UNITED STATES PATENT AND TRADEMARK OFFICE

APPLICATION NO.	FILING DATE	FIRST NAMED INVENTOR	ATTORNEY DOCKET NO.	CONFIRMATION NO.
10/550,717	07/20/2006	Altay Kismir	12400-043	6002
757	7590	01/13/2009	EXAMINER	
BRINKS HOFER GILSON & LIONE P.O. BOX 10395 CHICAGO, IL 60610			FREEDMAN, LAURA	
ART UNIT		PAPER NUMBER		
3616				
MAIL DATE		DELIVERY MODE		
01/13/2009		PAPER

DETAILED ACTION

FIG. 1

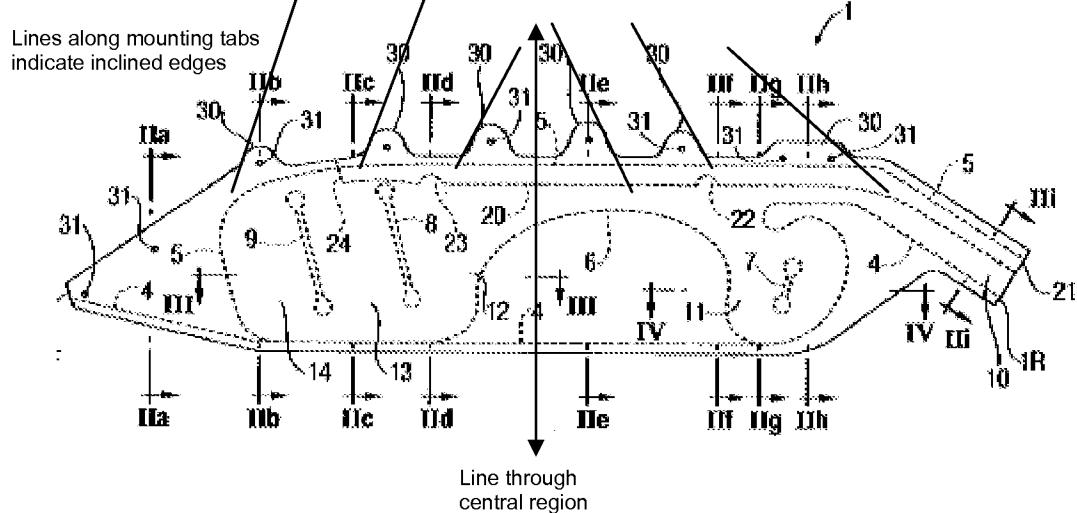
7. Claims 1-3 and 7 are rejected under 35 U.S.C. 102(b) as being anticipated by Masuda et al. (US 6,199,898). Masuda et al. disclose an airbag (for example, including inflatable curtain #1, 1A, 1B) comprising:

- At least one inflatable region (for example, including chambers #11-14)
- Upper edge (for example, including edge along top of airbag that includes mounting tabs) provided with a plurality of mounting tabs (for example, including #30)

- Each of the plurality of mounting tabs having an inclined edge (see marked-up drawing below) extending from the upper edge and inclined to define an angle of less than 90° with respect to the upper edge, and being inclined inwardly toward a line (see marked-up drawing below) lying vertically through a central region of the airbag

- At least one of the tabs is inclined at an angle between 30° and 80° (though drawings are not necessarily drawn to scale, incline angle is between 30° and 80°)

- Each of the plurality of mounting tabs comprises a single layer of fabric forming the air bag (for example, each of the tabs formed of the same fabric material as airbag; including top of column 2, bottom of column 3; can be seen in figures 1, 5-7).
